Re: BLM's Change to Implementation Action for Warrenella Gate Parking Lot &  
Demand for Supplemental NEPA Analysis

**Subject: Impacts on Warrenella Road Intersection with Cement Plant Road  
from Proposed BLM Access to Cotoni-Coast Dairies**

UNITED STATES DEPARTMENT OF THE INTERIOR  
 BUREAU OF LAND MANAGEMENT  
**Parking Lot Site Plan**  
 Warrenella Parking Lot  
 Central California District

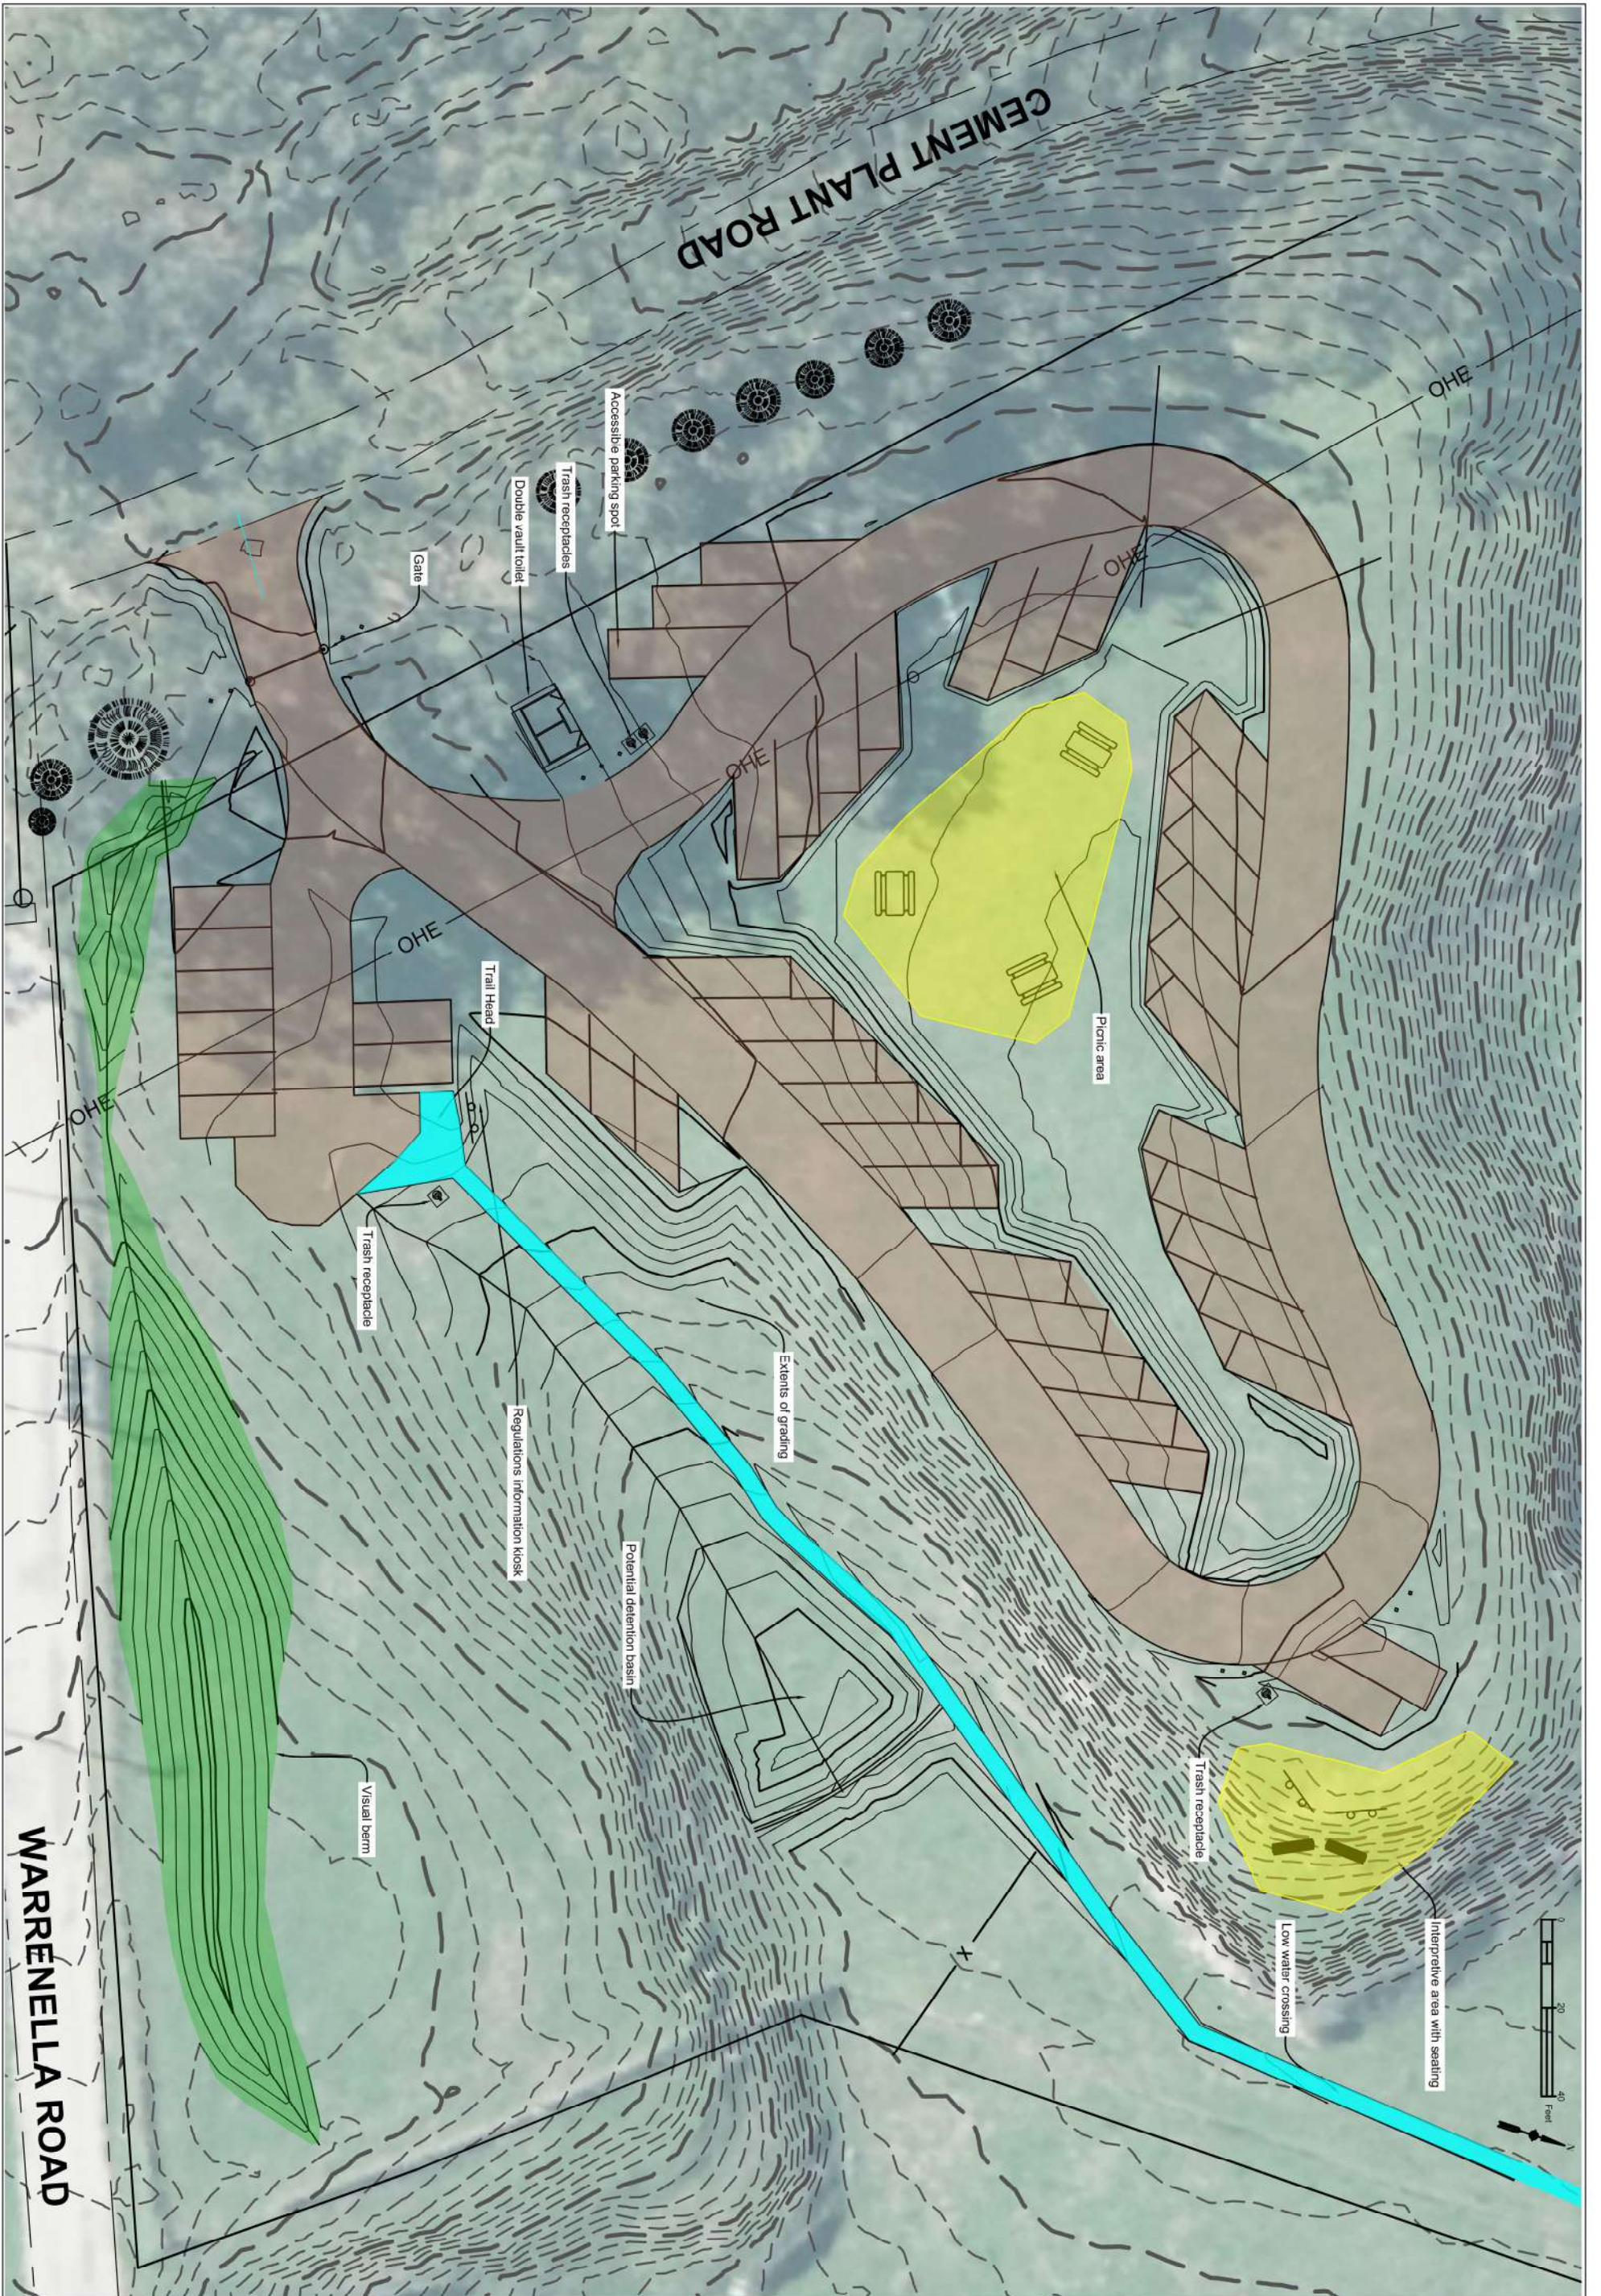
By the above deadline please also provide me with a full set of the nine-page "PLAN" for the Warrenella Gate Parking Lot dated 4/13/2022 by J. Parker P.E, page 1 of which is attached hereto as Attachment 2.

UNITED STATES DEPARTMENT OF THE INTERIOR  
 BUREAU OF LAND MANAGEMENT  
**Parking Lot Site Plan**  
 Warrenella Parking Lot  
 Central California District

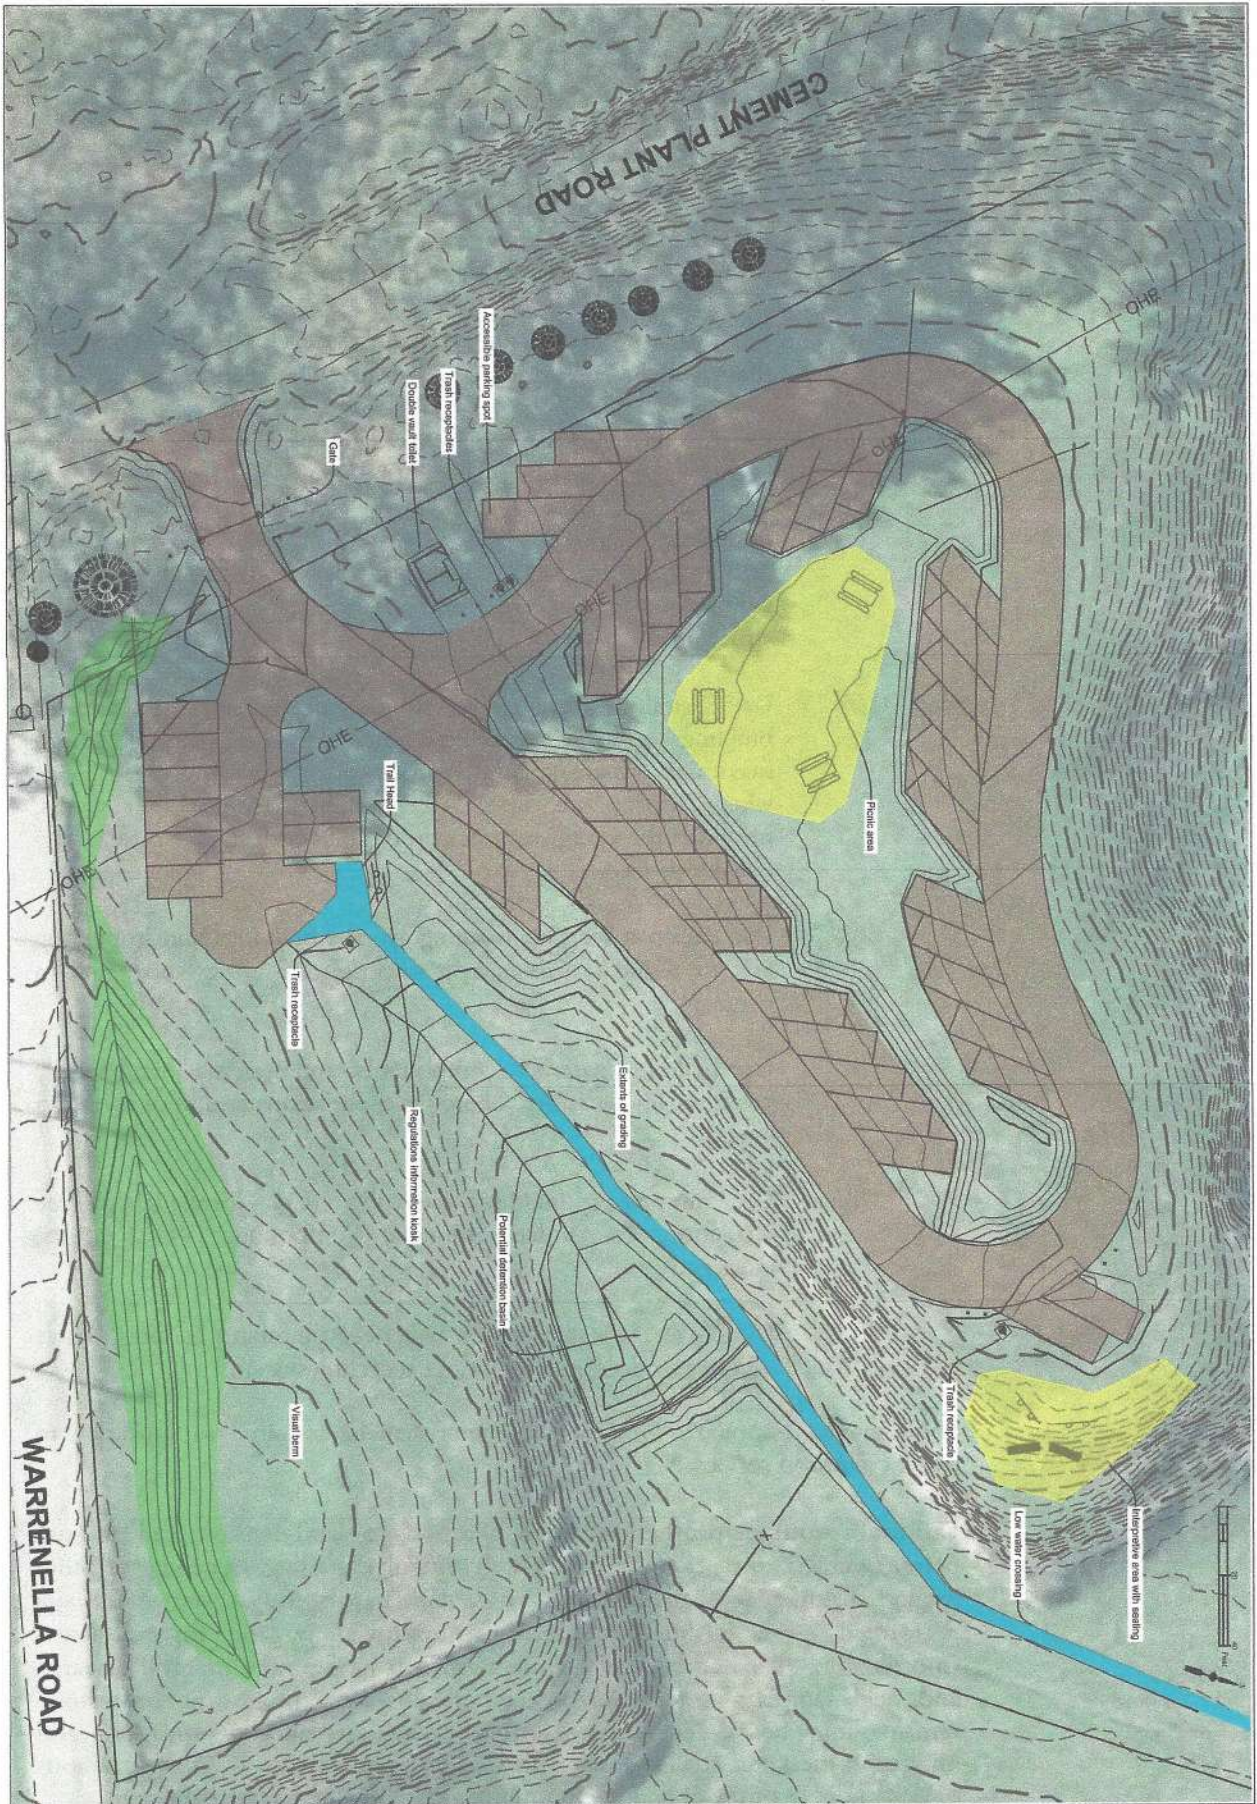
Warrenella Road intersection with Cement Plant Road is an existing legal encroachment. The traffic engineering question to be analyzed is whether BLM's proposed addition of an Access with Cement Plant Road approximately 60 feet to the north in order to serve a proposed 42-vehicle Parking Lot could interfere with such Warrenella Road intersection, or create hazards or nuisances.

BLM’s Access is close to Warrenella Road (60 feet, centerline to centerline). Cement Plant Road is a narrow road which varies from 15’ – 18’ in width in this immediate area. Warrenella Road has an associated locked manual gate which is approximately 60’ from Cement Plant Road.

The short 60 foot distance between Warrenella Road and the BLM Access does not allow for the margin of maneuverability that is needed for tractor-trailers turning right from Warrenella Road onto Cement Plant Road and heading north. Thus, vehicular conflict will occur between large trucks and passenger vehicles as a result of the new BLM Access being located only a very short distance of 60 feet from the existing Warrenella Road intersection. Utilizing AASHTO standards and terminology discussed in the next paragraph, Turning Templates were applied to determine that such conflicts will occur.

Pursuant to AASHTO Section 2.8.1 (p.2-55), in the design of any roadway facility, the designer should consider the largest design vehicle that is likely to use that facility with considerable frequency. At Section 2.8.2, p. 62 AASHTO states that "[f]or local roads and streets, the WB-40 [WB-12] is often considered an appropriate design vehicle." The Template for this design vehicle can be found at AASHTO p. 2-75, Figure 2-22, pursuant to which it can be determined that significant vehicular conflict, interference as to use of Warrenella Road, and safety impacts will occur if the newly proposed BLM Access is implemented.
